ADDENDUM NO. #0

TRACK & FIELD IMPROVEMENTS

Channel Islands High School

April 10, 2020

AD0-C1

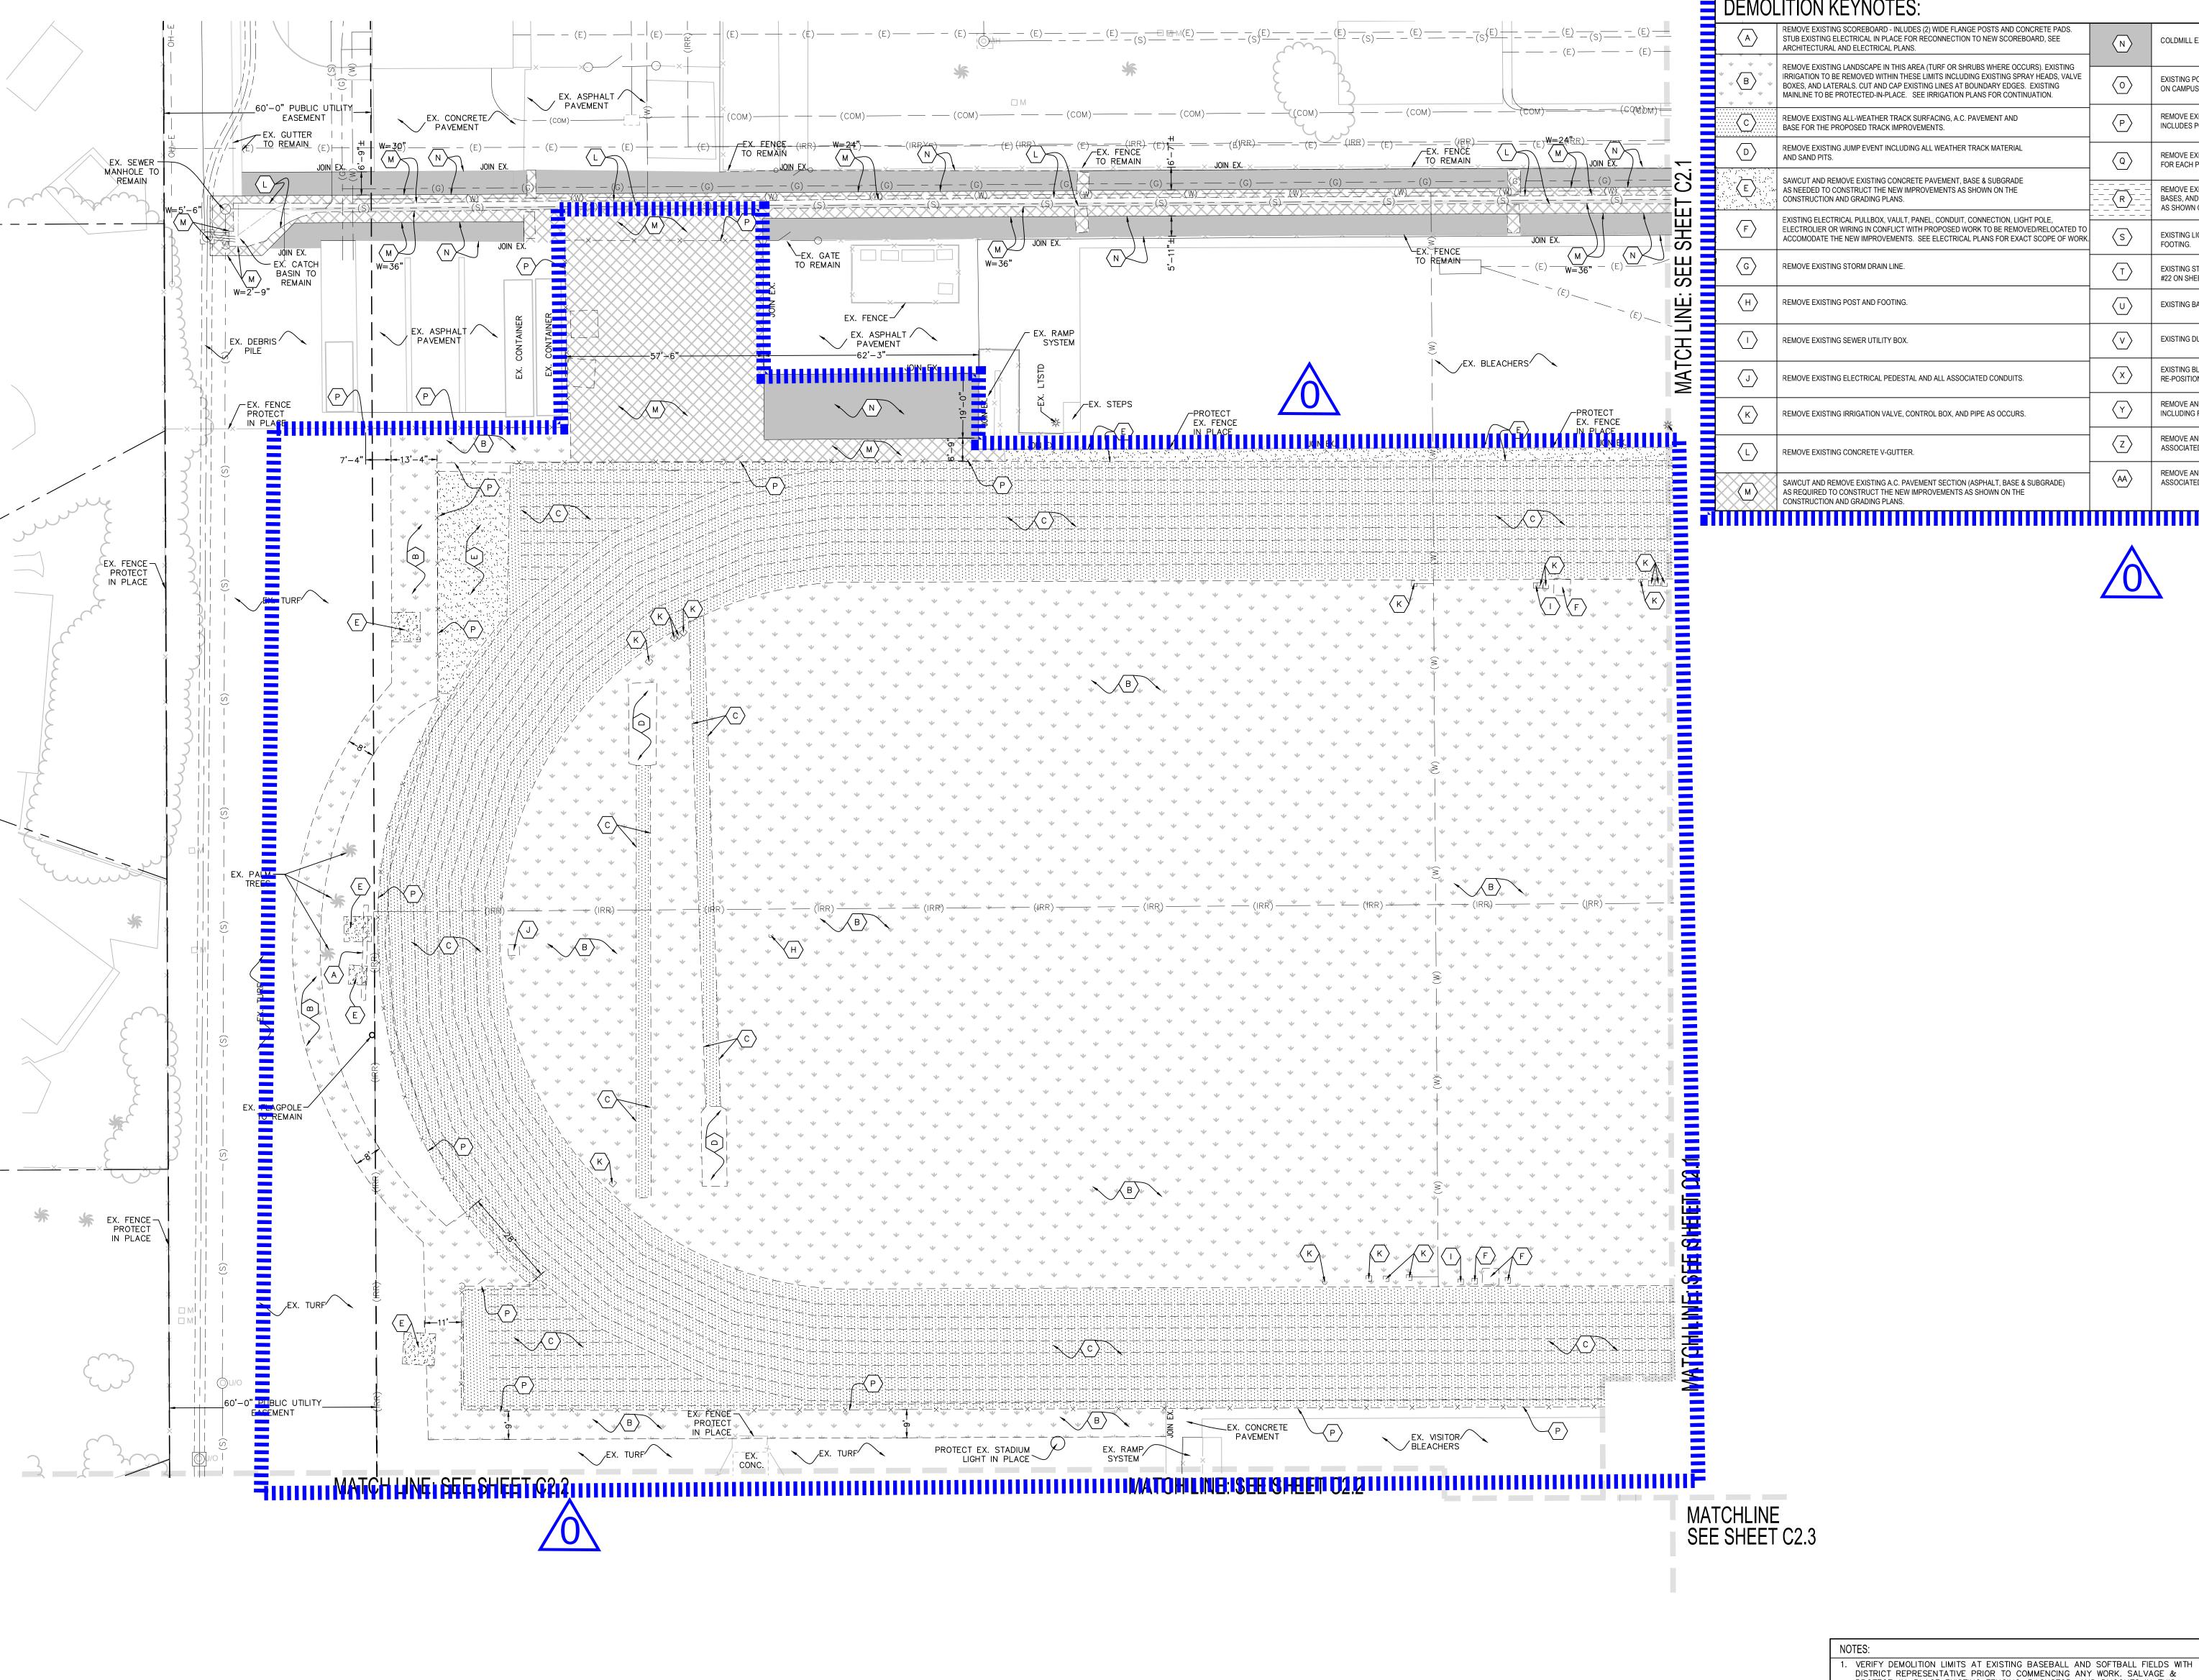
- **3.1.1.31.** Drawing C6.1: Revised Drawing per AD0-C21, see narrative.
- **3.1.2.** Narrative changes to Civil Drawings are issued as follows:
 - **3.1.2.1.** Drawing C1.0/AD0-C1 Area of work has been revised as shown on this sheet.

AD0-C2 C2.0

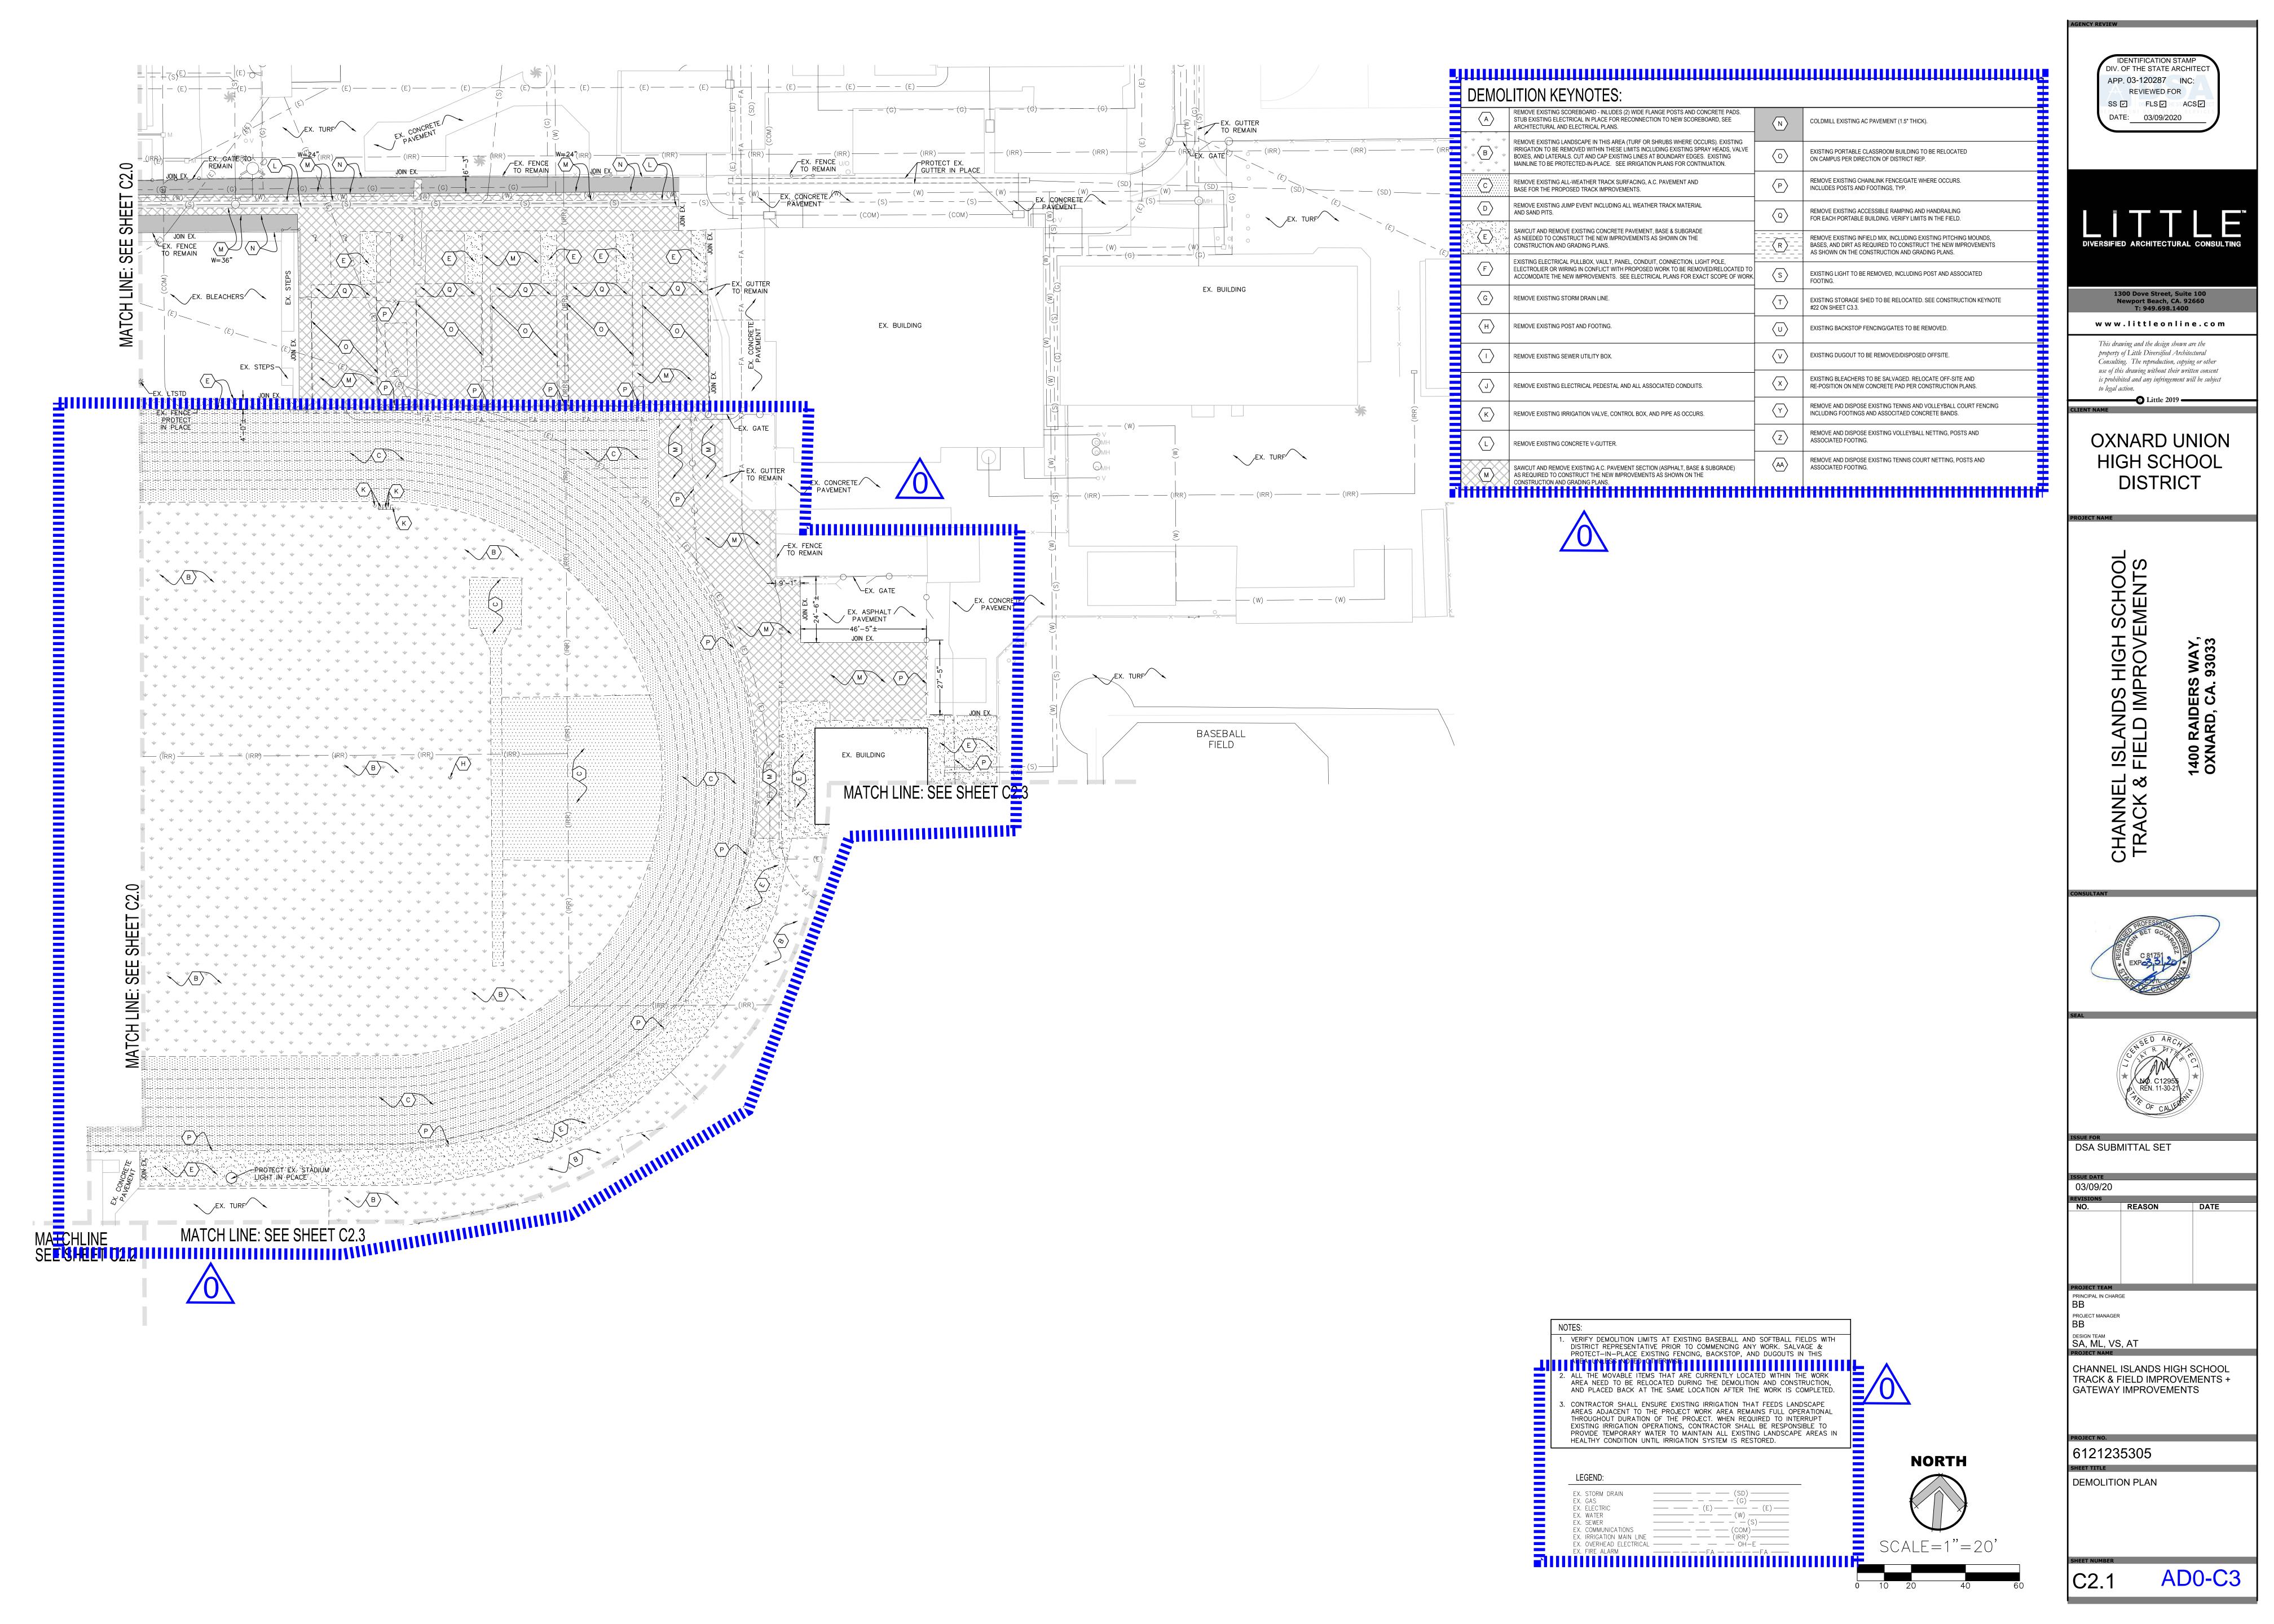
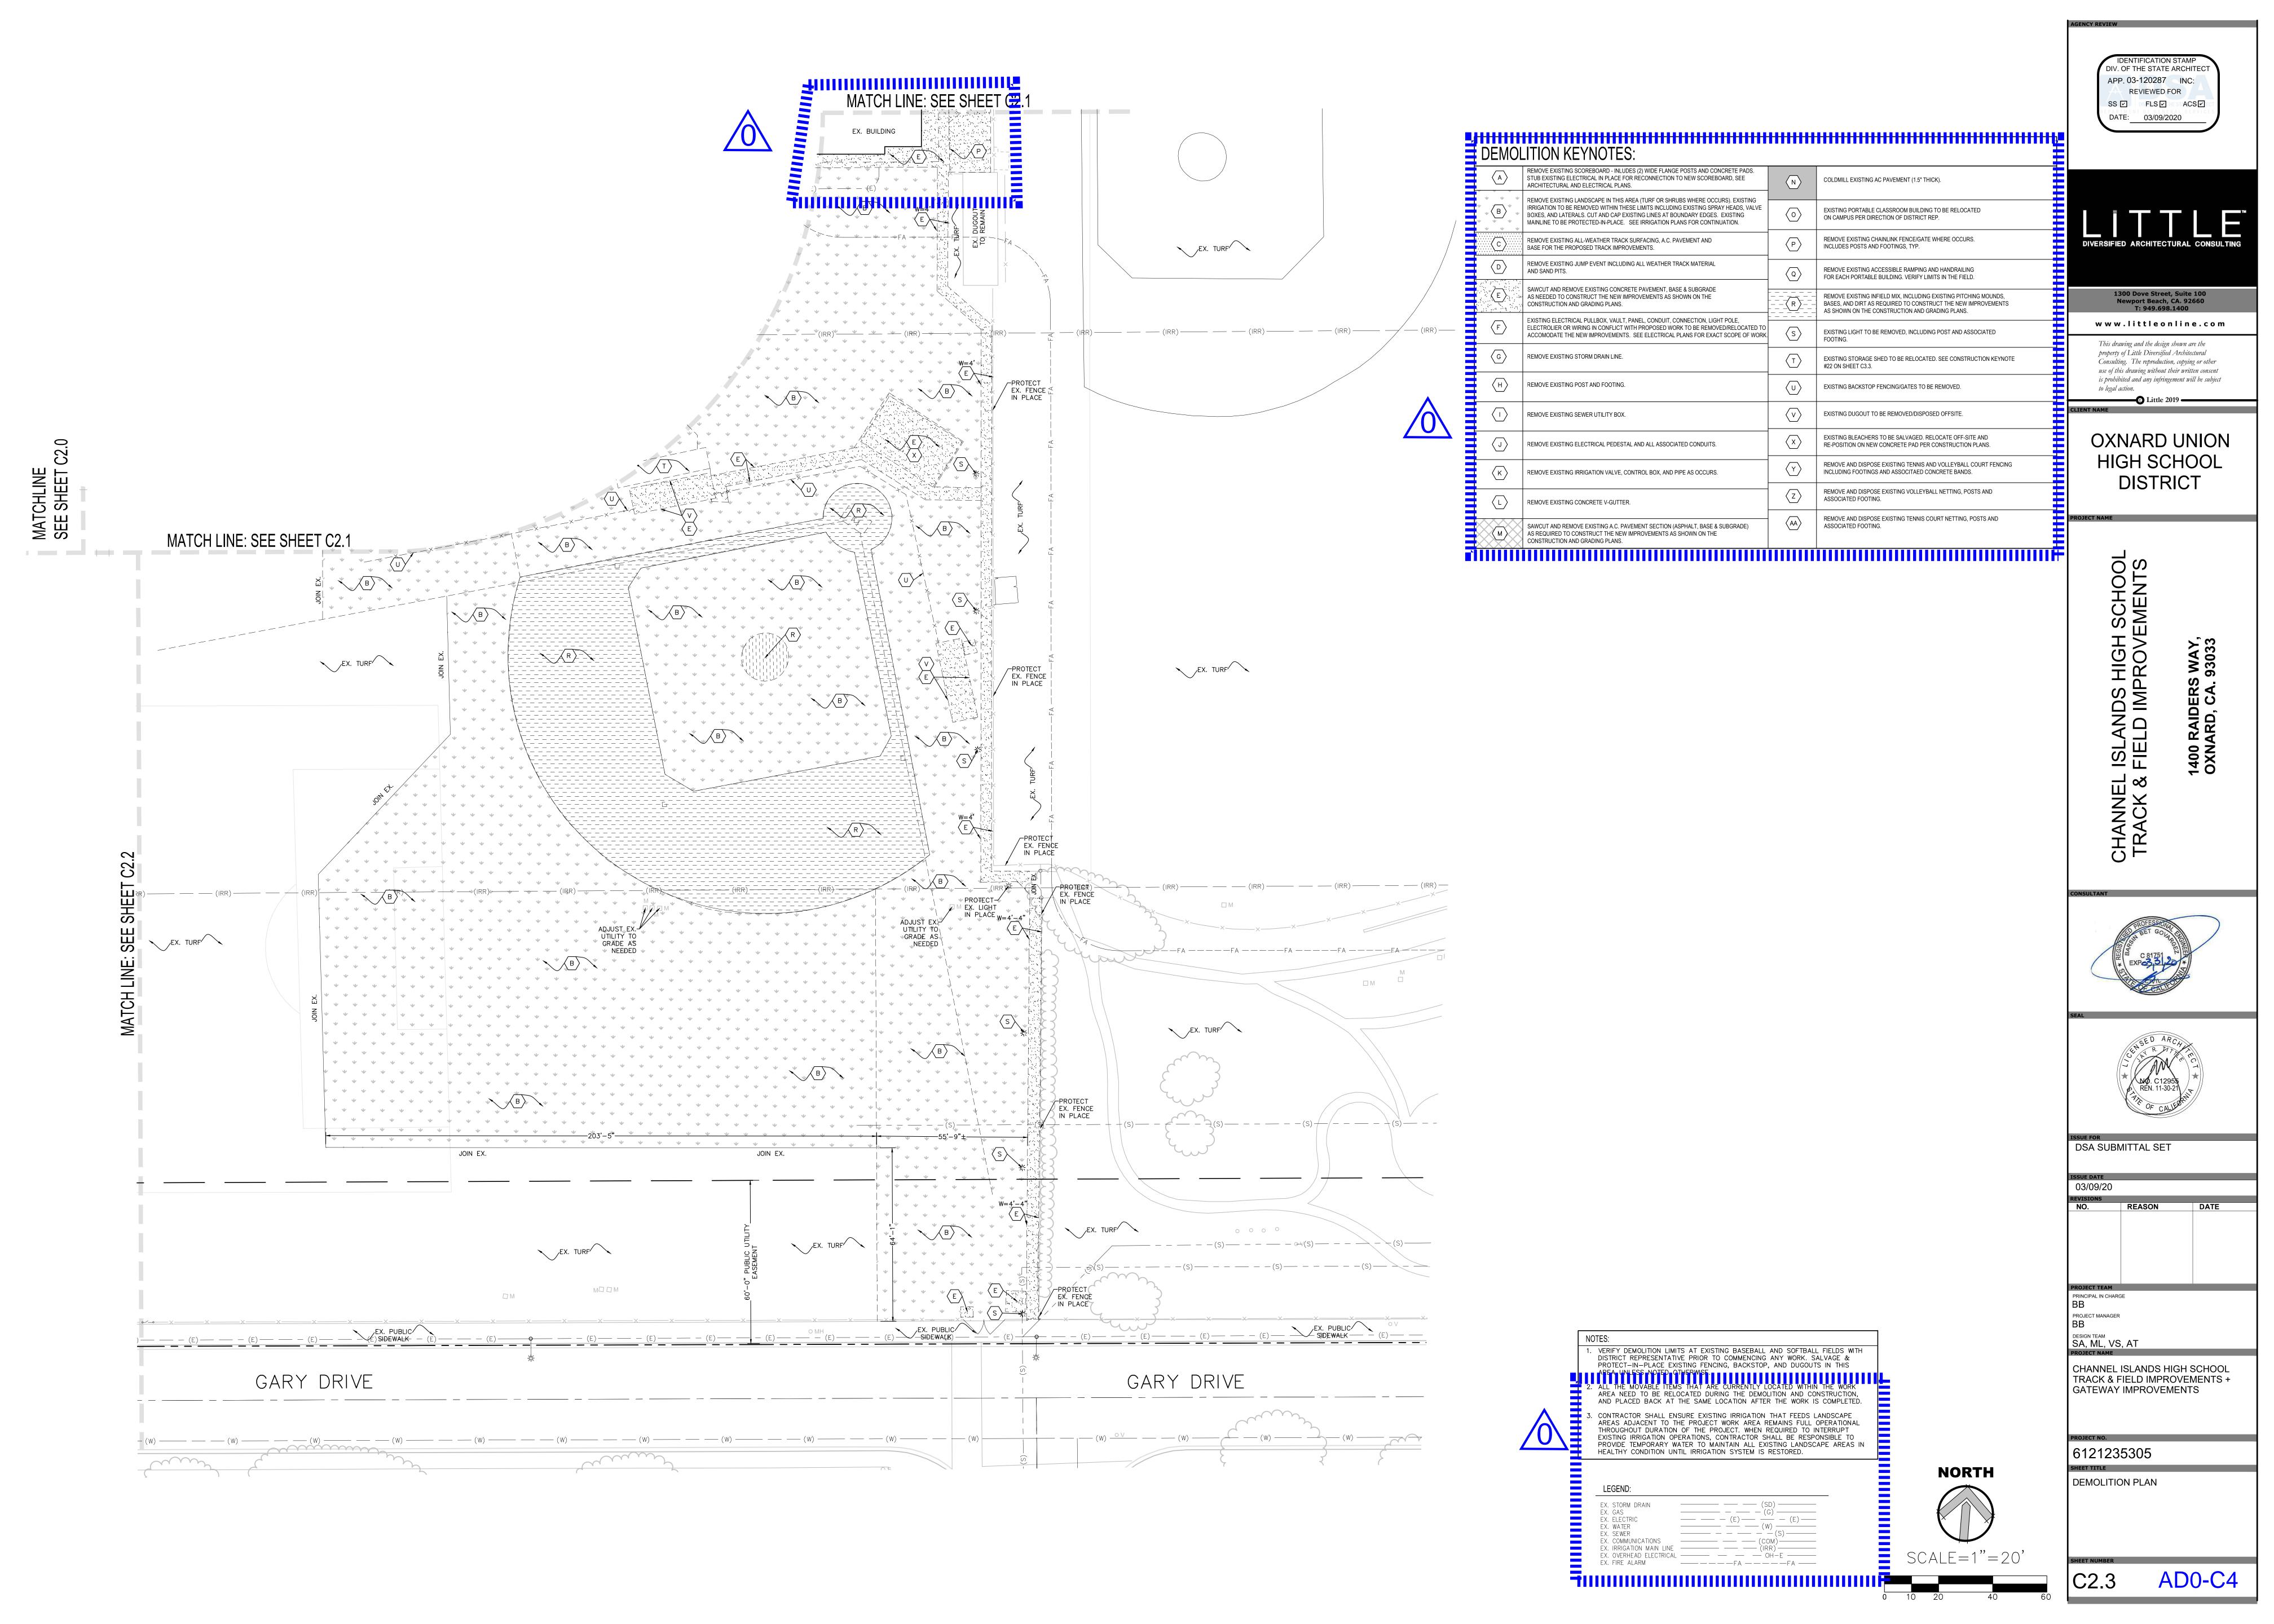
- **3.1.2.2.** Drawing C2.0/AD0-C2 Only work within outlined area is included in scope of this project and bid. Any work shown outside of the delineated area is not part of this project.
